Work Order ID 95258

Item Name: Crosstube Fwd High

DRAWING NO. D212-664-141	TITLE XTUBE ASSY (205/212/412 HI FWD)	REV. D	DART AEROSPACE LTD ENGINEERING ORDER		D.E.O. NO. D212-664-141-D-1	SHEET NO. SHEET 1 OF 2	SCALE NTS
DRAWN	CHECKED	OP	MFG. APPR.	APPROVED	DATE	DE APPR.	DATE
DATE 11.04.07	DATE 11.07.11		DATE 11.04.12	DATE 11/04/12		DATE 11.04.12

ADD AN INSPECTION WINDOW TO UNDERSIDE OF CROSSTUBE.

D212-664-141/-141B
ASSEMBLY DETAIL

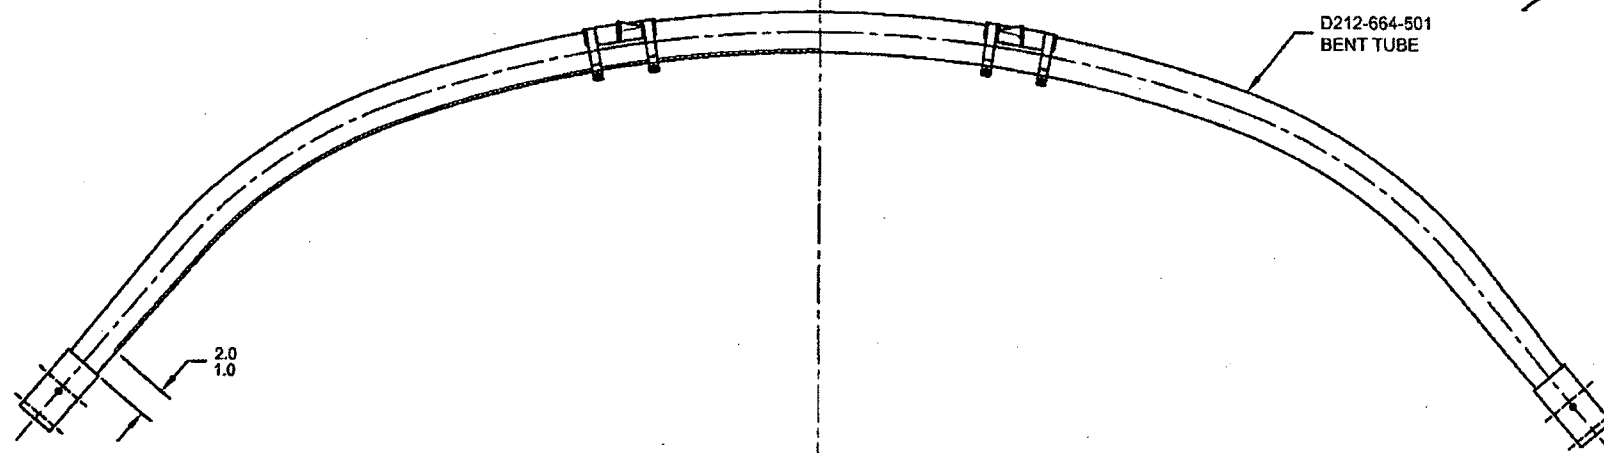
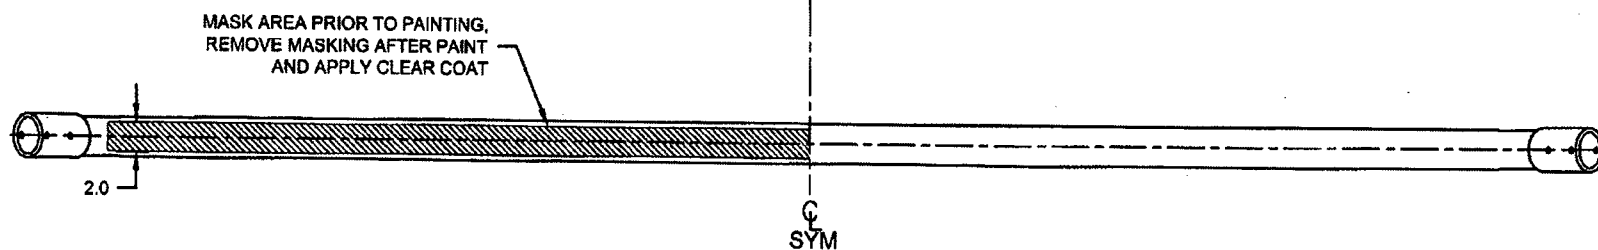
PURPOSE:

NOTES 2 OF SHEET 1 IS AMENDED AS FOLLOWS:

- 2) FINISH: CHEMICAL CONVERSION COAT PER DART QSI 005 4.1
PRIME INSIDE AND OUTSIDE PER DART QSI 005 4.2
MASK UNDERSIDE OF CROSSTUBE AS SHOWN (HATCHED AREA) AND
PAINT OUTSIDE PER DART QSI 005 4.2
REMOVE MASKING AND APPLY CLEAR COAT

- 2) FINISH: CHEMICAL CONVERSION COAT PER DART QSI 005 4.1
PRIME INSIDE AND OUTSIDE PER DART QSI 005 4.2
PAINT OUTSIDE PER DART QSI 005 4.2
